# Access Compliance Report

## Public Rights-of-Way (Curb Ramps)

Intersection ID: 51504	Main Street: DUNSLOW_CT	Cross Street: EASTFIELD_PARK_DR	Location:	N
ADA ID: 20CB17025770	Ramp Type: PerpDiag	Initial Pass/Fail: Pass	Overall Compliance: No	Severity Score: 0

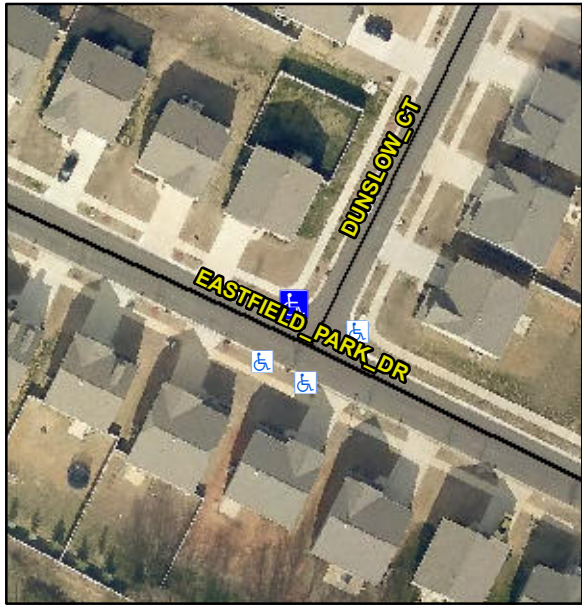
Codes/Mitigation Info/Possible Solution			Field Measurements/Component Compliance					
	Possible Solutions:		Compliance	Description	Data	Compliance	Description	Data
	Remove & Replace Curb Ramp With Two New Directional Ramps or Equivalent. Remove & Replace Gutter.		N/A	Ramp Length (in)	72.0	Yes	Ramp Slope (%)	5.9
			Yes	Ramp Width (in)	48.0	Yes	Ramp XSlope (%)	1.6
			N/A	Flare Type LT	Sloped	N/A	Flare Type RT	N/A
			N/A	Flare Slope LT (%)	4.7	N/A	Flare Slope RT (%)	0.5
			N/A	Flare Traversable LT?	No	N/A	Flare Traversable RT?	No
			Yes	Landing Length (in)	58.0	Yes	DWS Provided?	Yes
			Yes	Landing Width (in)	48.0	Yes	DWS Contrast?	Yes
			Yes	Landing Slope (%)	1.6	Yes	DWS Length (in)	24.0
			No	Landing X Slope (%)	3.4	Yes	DWS Full Width?	Yes
Surveyor Notes:			N/A	Landing Curb? (Y/N)	No	No	DWS Offset (in)	2.5
PROW/ADA:			N/A	Shared Landing?	No			
Not Found, R304.5.3, R305.2			Yes	Gutter Ponding?	No	Yes	Gutter Slope (%)	4.5

Yes	Gutter Lip Ht (in)	0.0	No	Gutter X Slope (%)	2.3
			N/A	Painted X Walk1?	No	N/A	Painted X Walk2?	No
				X Walk 1 Direction	To SW		X Walk 2 Direction	To SE
			N/A	X Walk 1 Width (in)	N/A	N/A	X Walk 2 Width (in)	N/A
				X Walk 1 Slope (%)	5.9		X Walk 2 Slope (%)	4.0
				X Walk 1 X Slope (%)	2.0		X Walk 2 X Slope (%)	4.5
			N/A	Ramp inside XWalk1?	N/A	N/A	Ramp inside XWalk2?	N/A
				Road Slope (%)	2.3	N/A	Clear Space?	Yes
				Road X Slope (%)	6.7	N/A	Clear Space to XWalk (in)	N/A
			Yes	Any Obstructions?	No	Yes	Storm Grate/Utility Hazard?	No
				Obstruction Type			Storm Grate/Utility Type	
						N/A		N/A
						Yes	Surface Condition? (G/P)	Good
Total Cost:		\$ 3950.00
